**REPORT OF THE JOINT COMMITTEE APPOINTED BY HON'BLE NGT (SZ) IN O.A NO. 225 OF 2021, AS PER ORDER DATED 22/11/2021, REGARDING LARGE SCALE CONSTRUCTION GOING ON IN THE CRZ AREA WITHOUT OBTAINING NECESSARY PERMISSIONS IN KARWAR BEACH AND KALI RIVER BANK IN THE STATE OF KARNATAKA KARWAR TALUK, UTTARA KANNADA DISTRICT -REG.**

Site locations super-imposed on existing approved CZMP as CRZ Notification 2011

# CRZ Map for the Public Toilet, Karwar, Karnataka

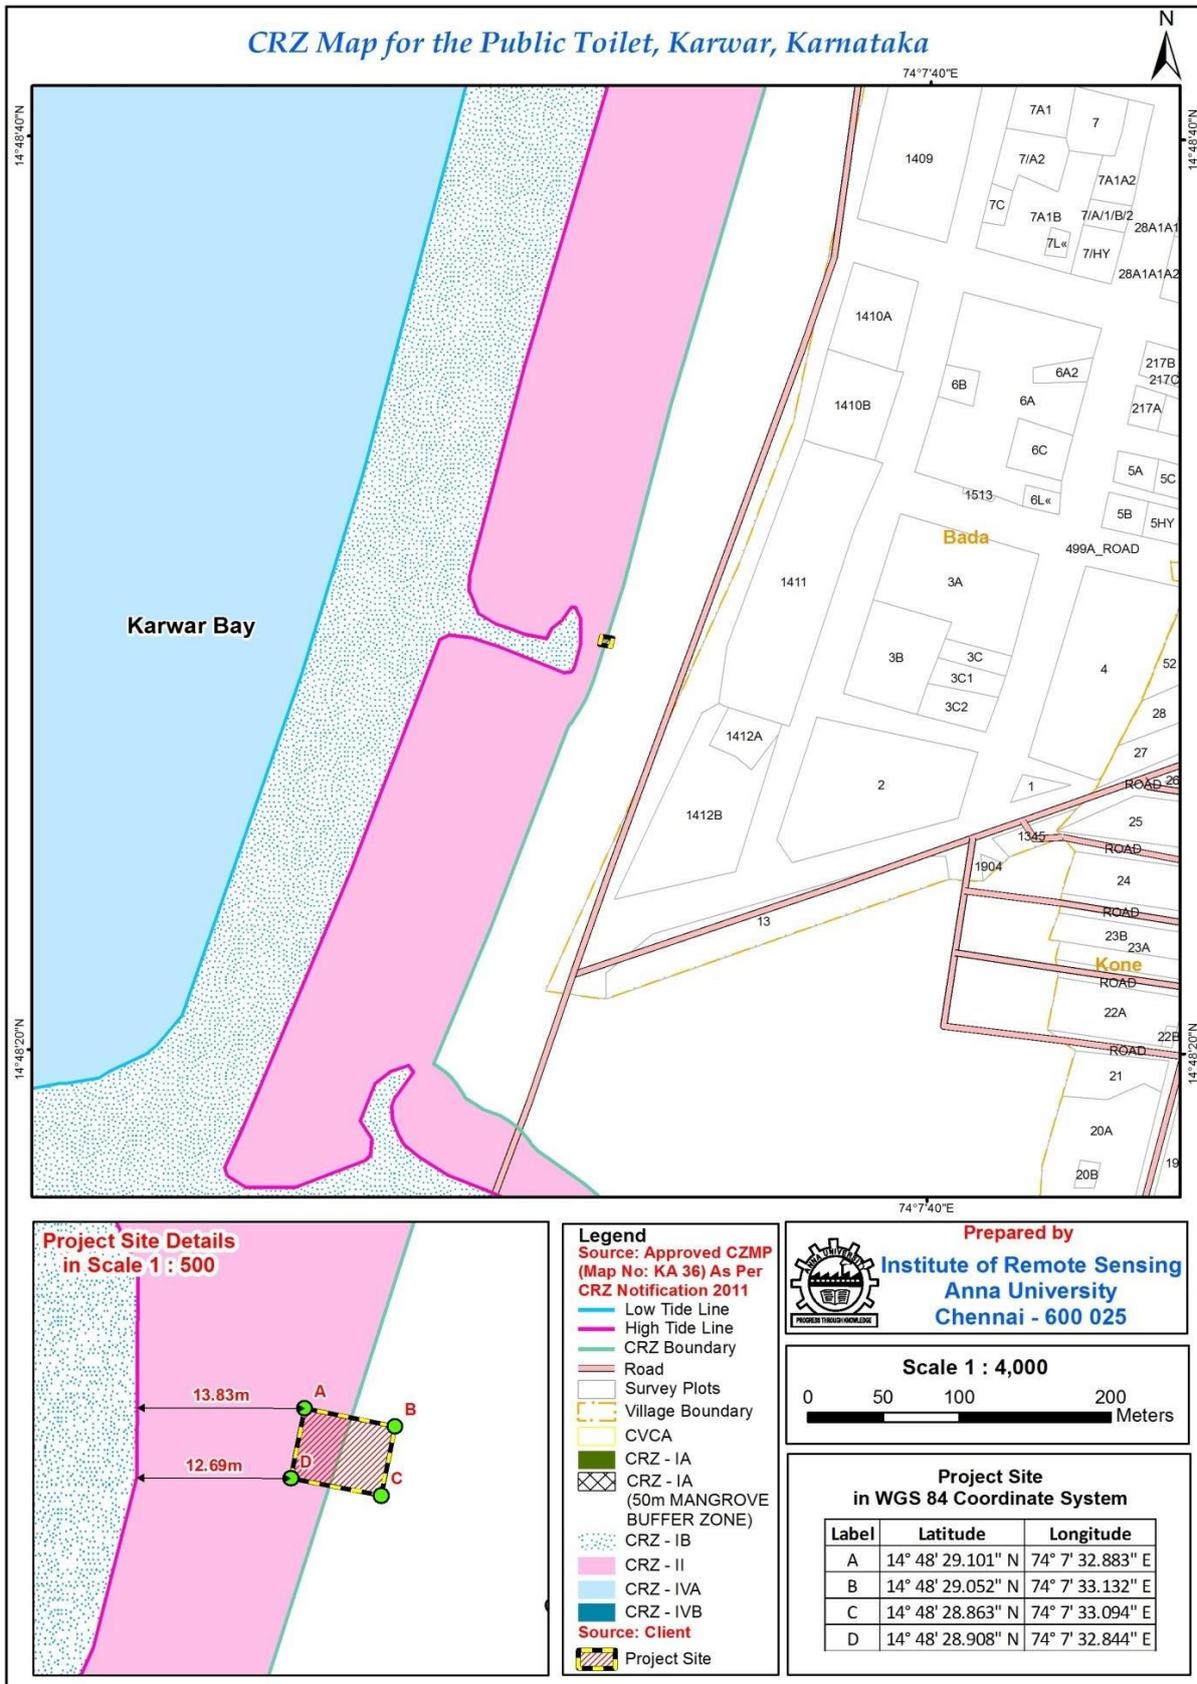
From the map, it is inferred that part of the public toilet is in CRZ-II zone, however same is not is use after shifting of Fish market to the town.
